DA 2013/26

Lot 2 DP: 242183, 2 Henderson Place LENNOX HEAD

Replacement of garage and construction of two carports

I wish to respond to the eight page objection but forward by Michael and Carlan Plowman of 1 Henderson Place Lennox Head on the 1st March 2013.

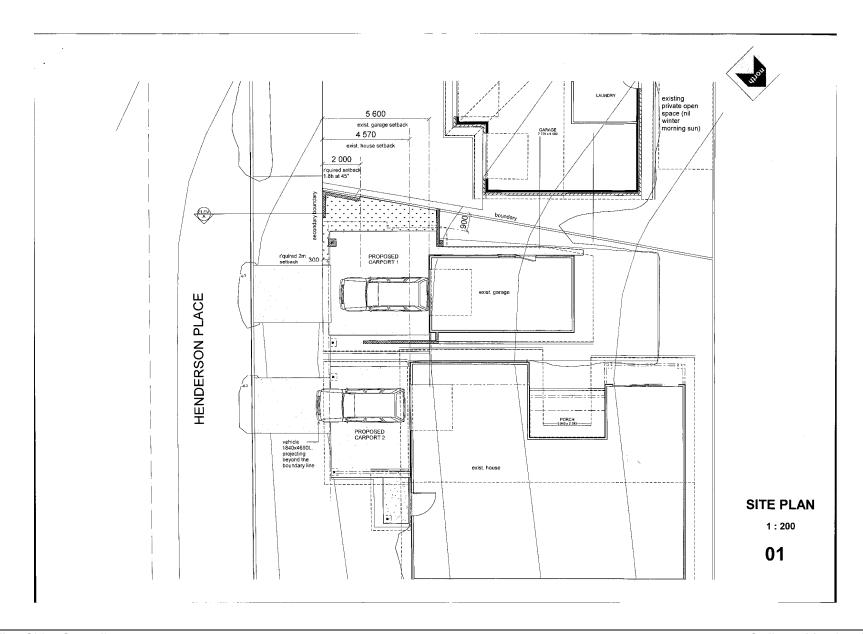
Please refer to plan dwg 05 Shadow Diagram, we have drawn in our future private open space area, adjacent to Henderson Place, as you can see it directly blocks out our early morning sun, which to us is a total disadvantage to our quest for morning light, sun and morning relaxation before work in winter time.

If you want sun in winter you don't put a sundeck close to a building on the Southern side of your house! I find it hard to believe the Plowmans seriously intend to be sunning themselves at 8:30 am during winter on the shortest day of the year. If they waited 30 minutes they would have it! Come summer they would be looking for shade over that area!

Allowing for the fact that we have asked for an exemption regarding a "zero setback on the front boundary", even if the carports were allowed and set back as per the regulations (no exemption), it would not significantly change the morning light and shadows over Mr Powman's proposed Future Private Space. The bottom line is that our renovations as a whole have actually increased the amount of morning sun in his front yard, again please refer to Google Earth and the bushes along the adjoining fence line.

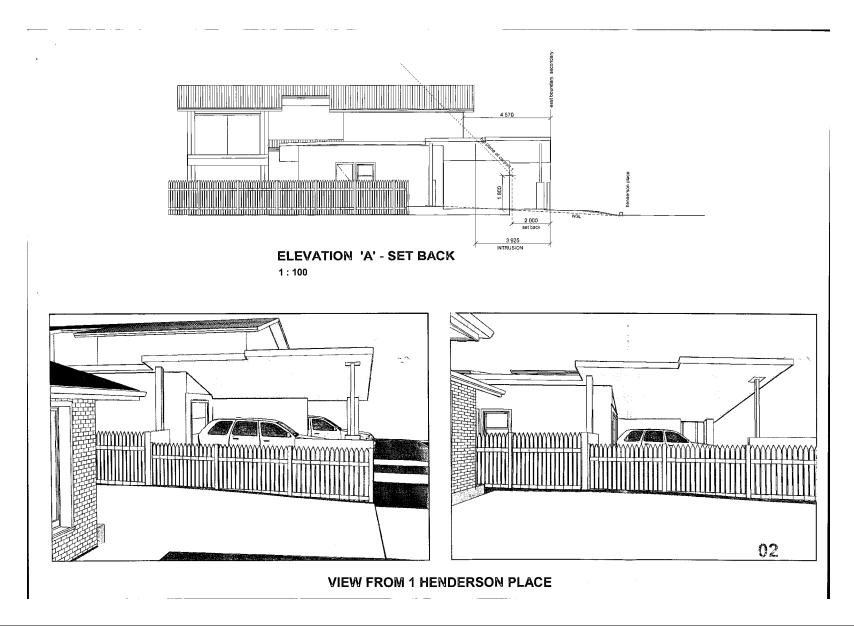
Having said that, consider our plan, 02 Elevation A Set Back, this elevation clearly demonstrates the oversight of this development, there is an approximate intrusion of 3900m which equates to + or -75% of the carport roof structure, a direct violation.

Staying on plan sheet 02, the perspective visuals demonstrate the direct disobedient set back proposal, these shots are what this development will be from our private open space, total structure obtrusion and depleting the existing vista to the natural surroundings.

We are requesting a front boundary exemption. This is not unusual and with precedents already set (eg. 10 Henderson Place) and with the approved DA's granted to Lot 2 over the last 20yrs there is not a great deal of room to move — so to speak. Note that the footprint of both units, walls of the buildings and the garage are not changing. The new roofs are virtually the same height as the existing! The proposed carports have no walls or screens. We are required to provide parking for 4 cars so the position & size of the driveway is not an issue in this objection. The cars will be parked on the driveway regardless of the Plowman's objection. We believe it is reasonable to request

04

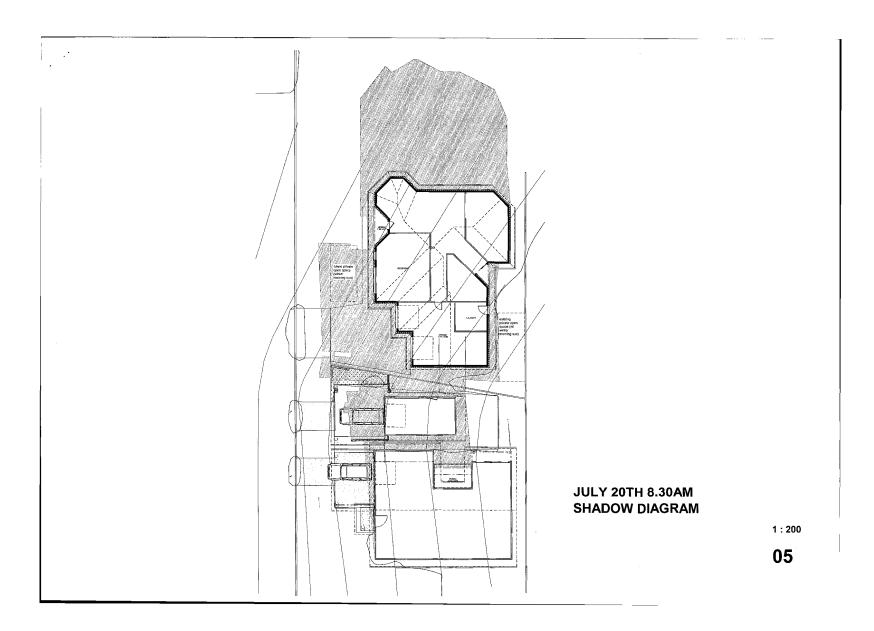
Aesthetics, aesthetics must be taken into consideration by all parties concerned, for example please refer to plan dwg 03 & 04, here we demonstrate the streetscape visuals on the approach from turning into Henderson Place, whether your driving or walking in a northerly direction, you can now witness from our 3D perspectives, not orthographic plans which are void of all visual reality, whereby our plans clearly show the ugly inheritance that this structure would develop.

Aesthetics – We are quite happy with the aesthetics but have no objection to planting bushes along the fence line between the properties thus blocking out the Plowmans view of the carports. I can choose bushes that don't grow too high and reduce the sunlight from their "Future Private Space" as
